Transbay Transit Center Program

Final Supplemental Environmental Impact Statement/ Environmental Impact Report

Volume 1: Final SEIS/EIR

November 2018

Recommendation #1

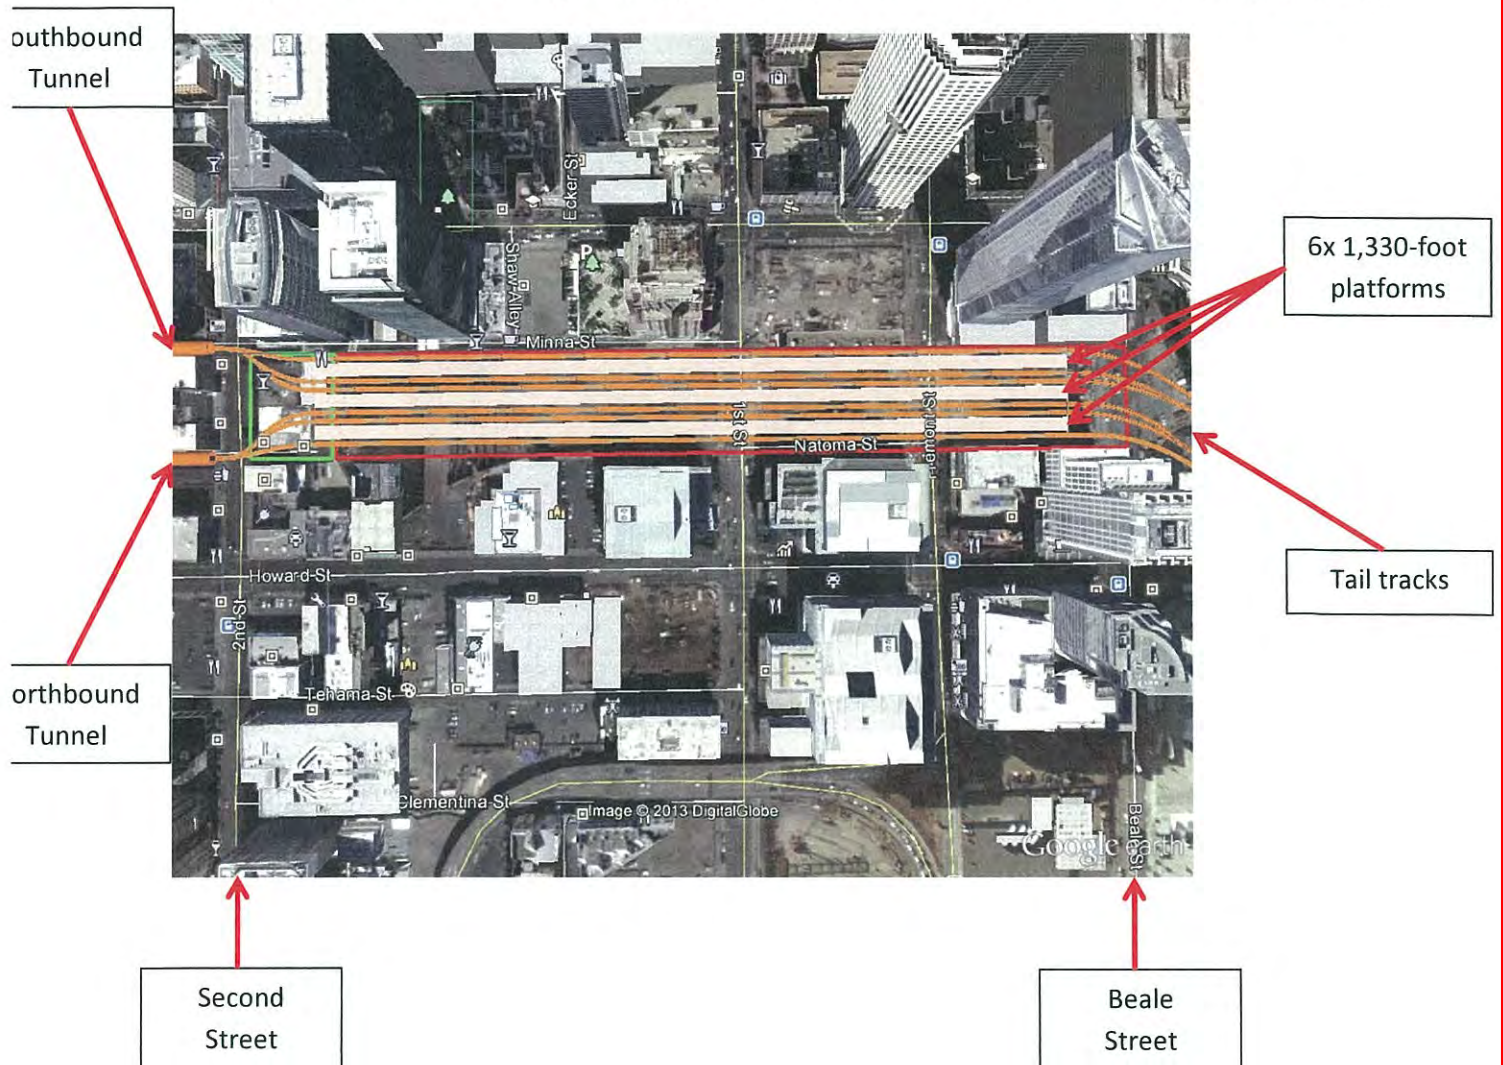
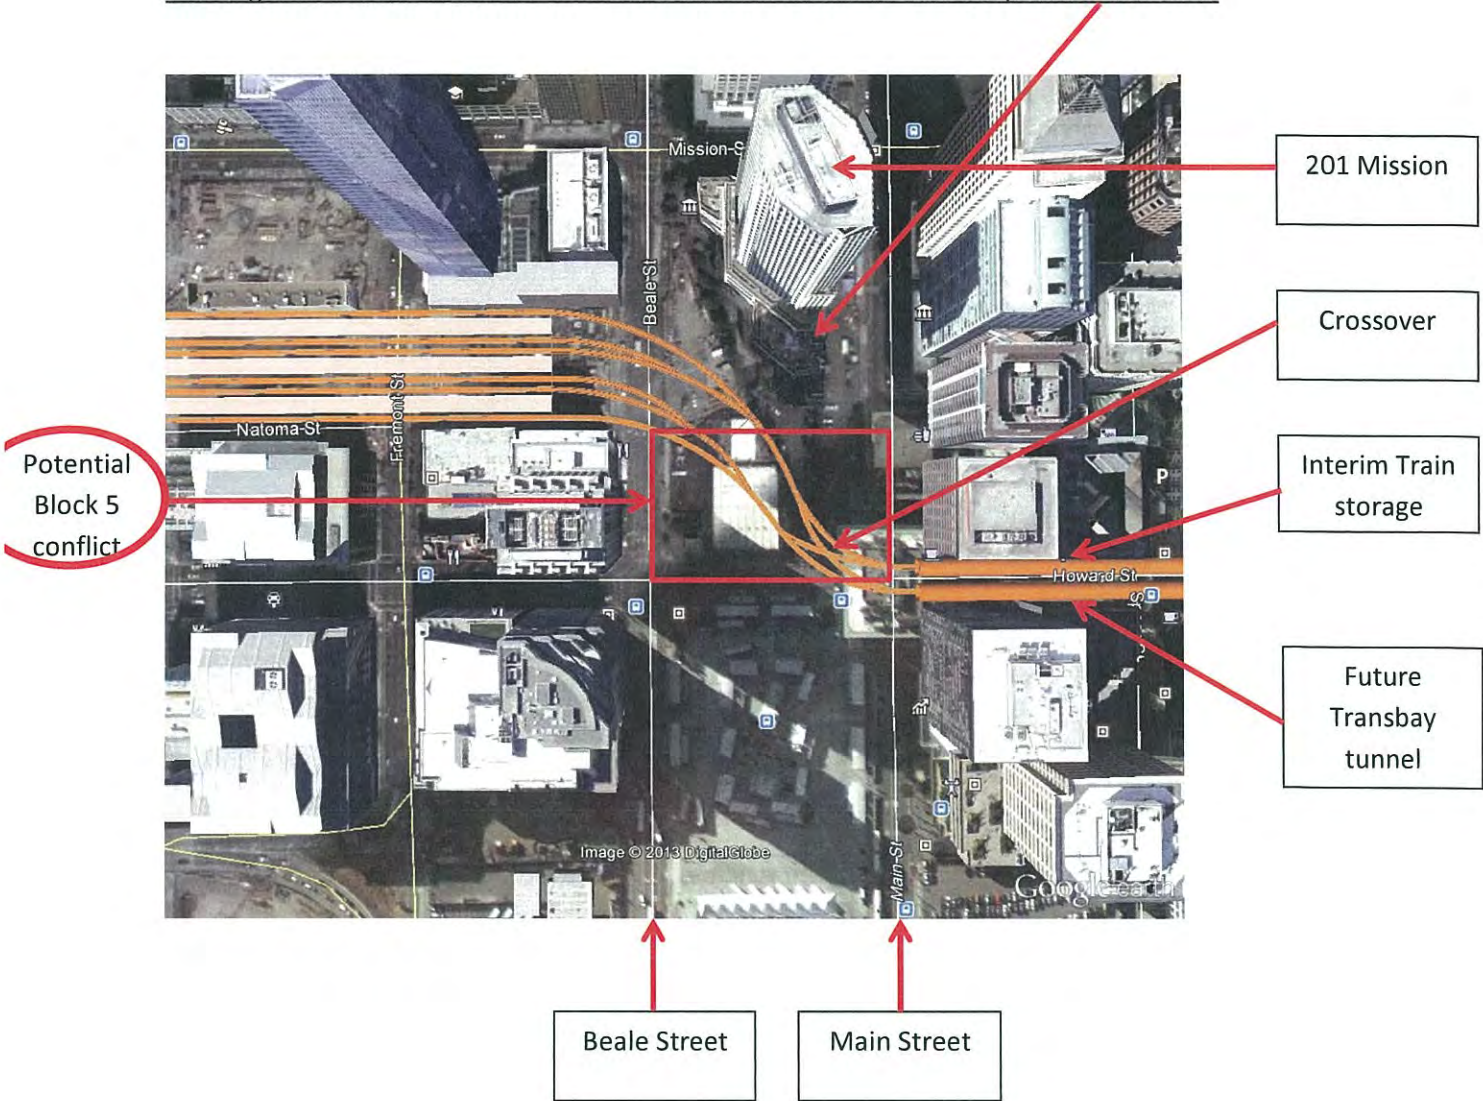
The SEIR should consider an alternate DTX alignment which would enable platform lengthening by extending the train box one block west (towards 2nd Street) while simultaneously providing a viable connection to a Transbay tunnel. This alignment would also eliminate conflicts with the 201 Mission building and enable a 6th full-length through platform (total 3 eastbound and 3 westbound platforms).

This alignment would eliminate the need to demolish the 201 Mission podium structure.

2) Widened throat structure

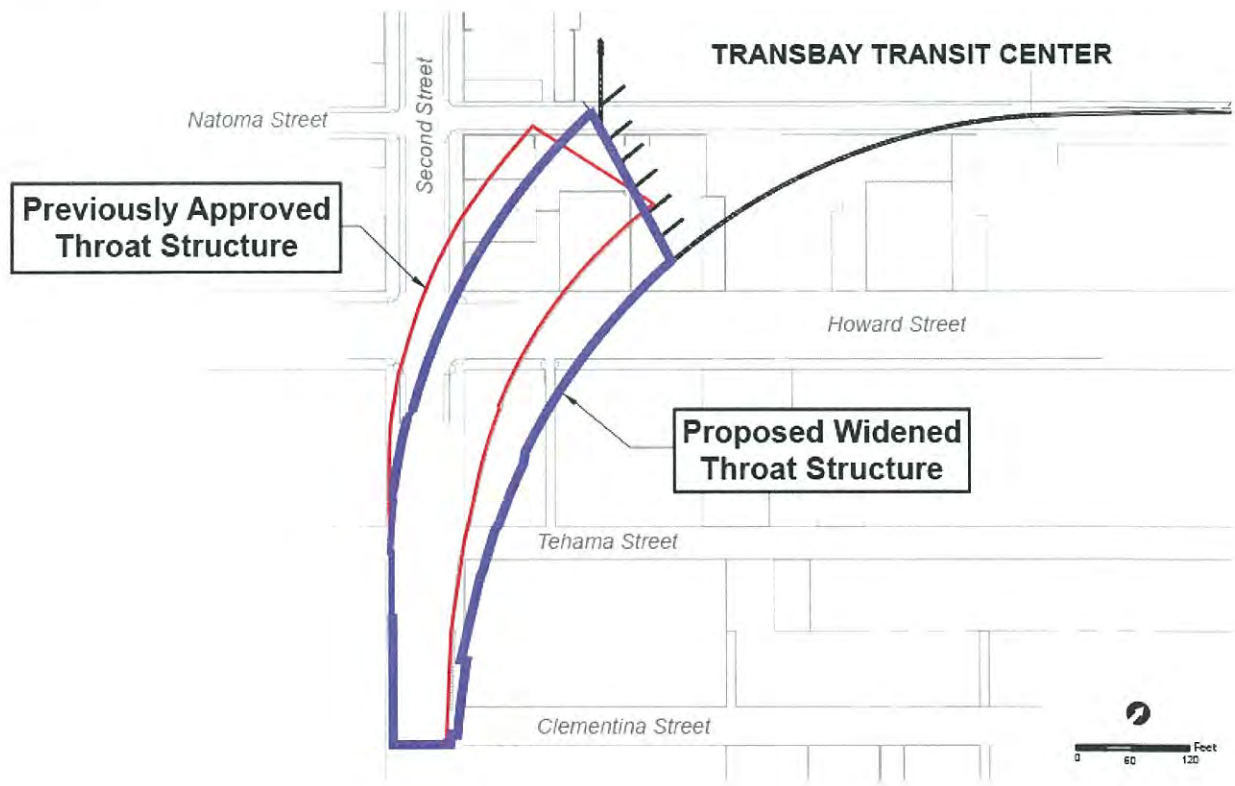
The SEIR proposes a widened approach to the Transbay Center train box via a massive cut & cover structure that will impact numerous properties as far south as Clementina Street. Construction costs are expected to run into the hundreds of millions and will result in massive circulation and noise impacts on the adjacent neighborhoods for many years.

Recommendation #5

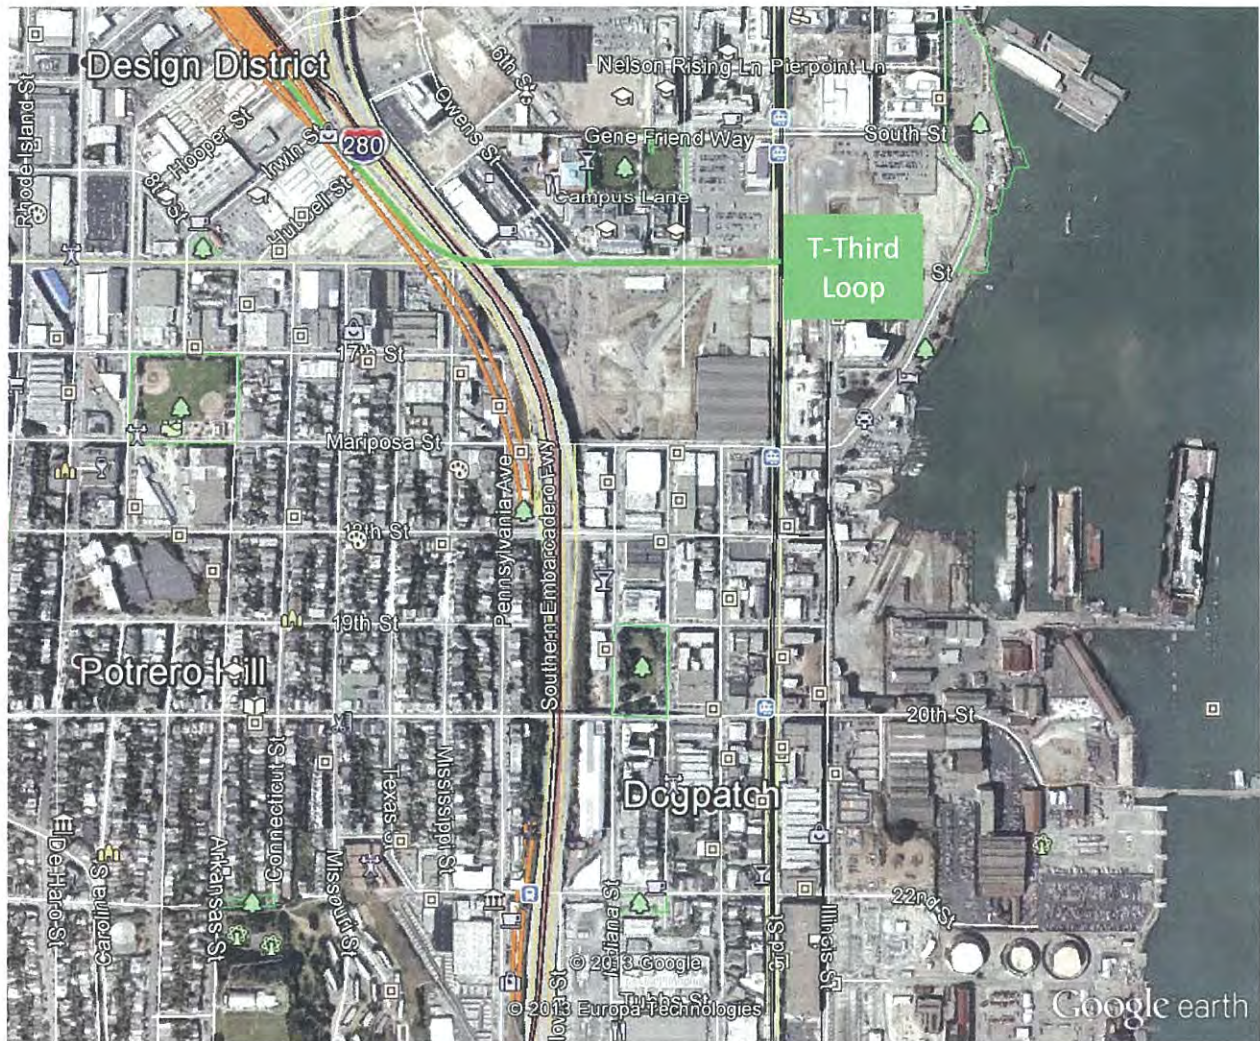
The SEIR should consider a direct connection to the Planning Department's Pennsylvania Avenue RAB study alternative. This would achieve 16th Street Grade separation as soon as Caltrain operations are relocated to the Transbay terminal and would save hundreds of millions by eliminating cut & cover structures @ 7th & Townsend

6) Turnback Track impacts on 16th Street grade crossing

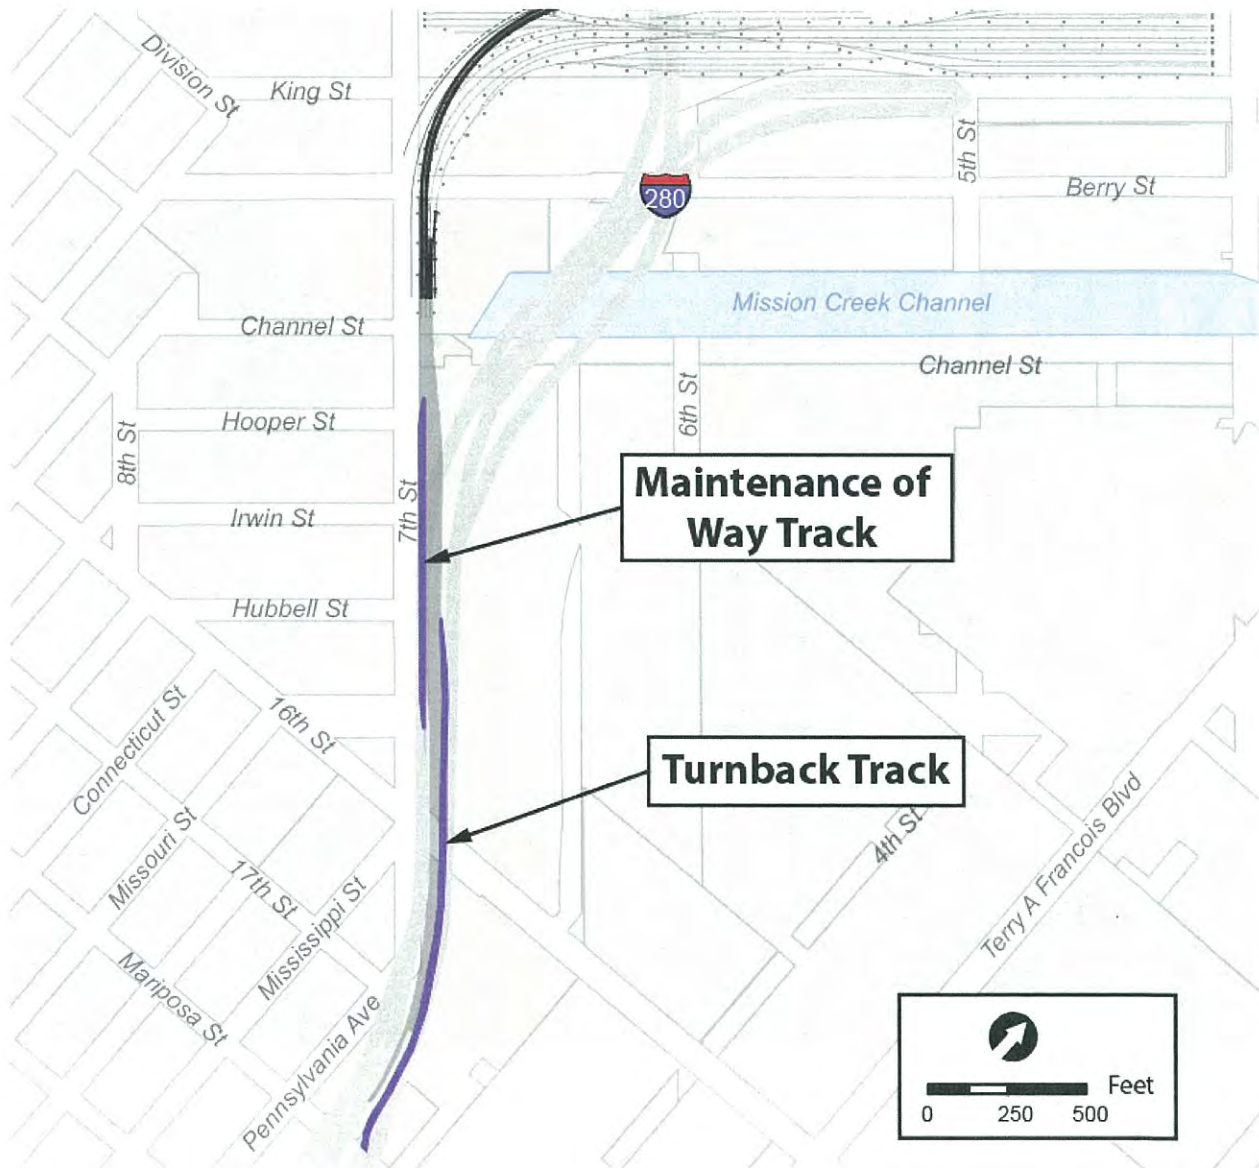
The SEIR proposes the addition of two additional tracks on 7th Street, including a turnback track across 16th Street, thereby increasing gate downtime for each train crossing by an additional 10 seconds (10 minutes per day).

Recommendation #7

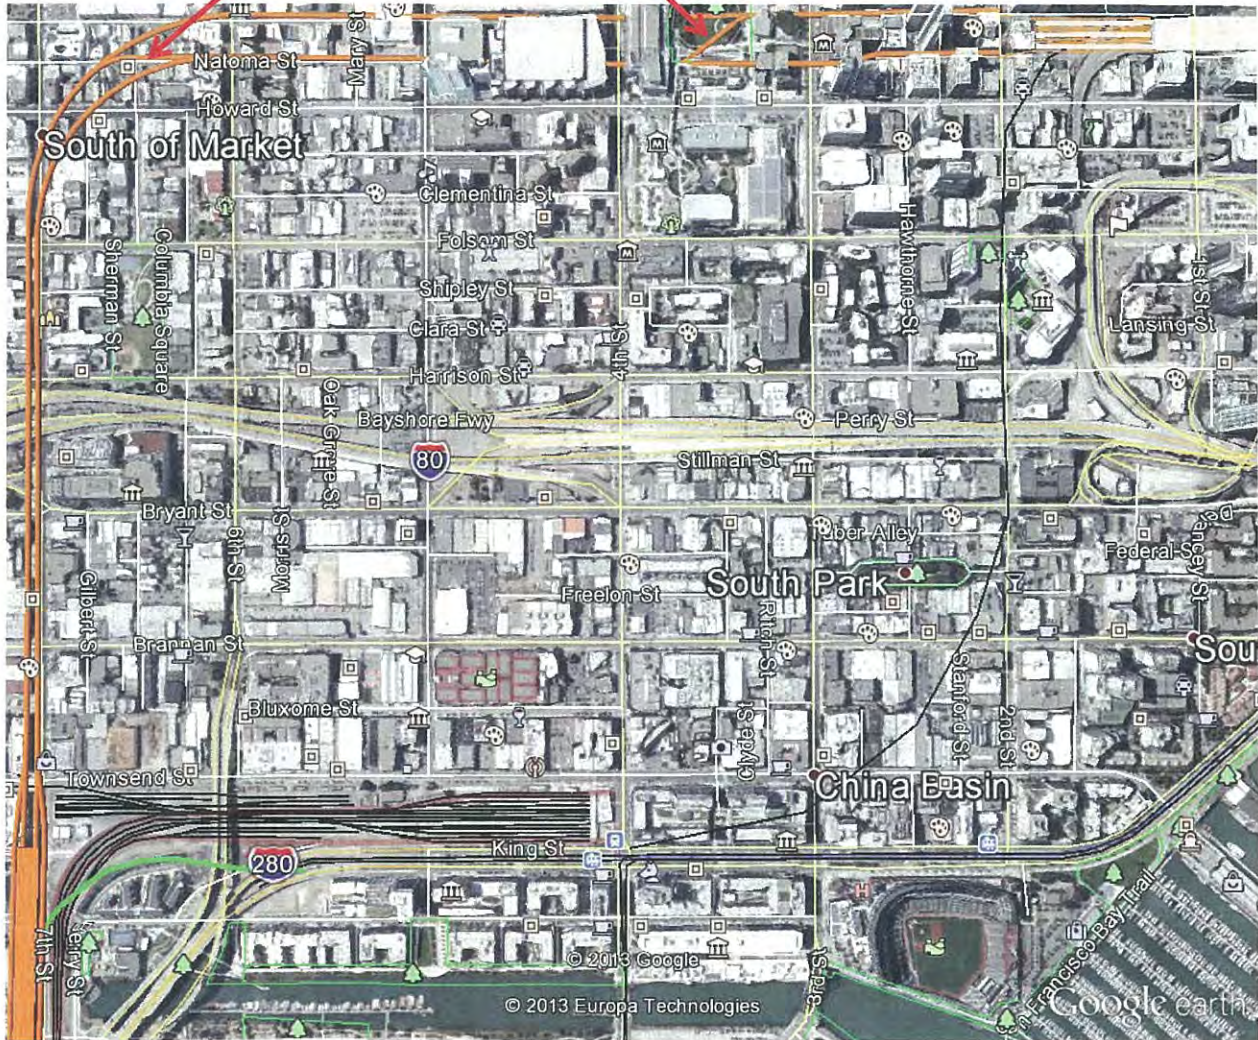
The SEIR should consider an alternate alignment designed to enable an 80 MPH approach to the Transbay Transit Center.
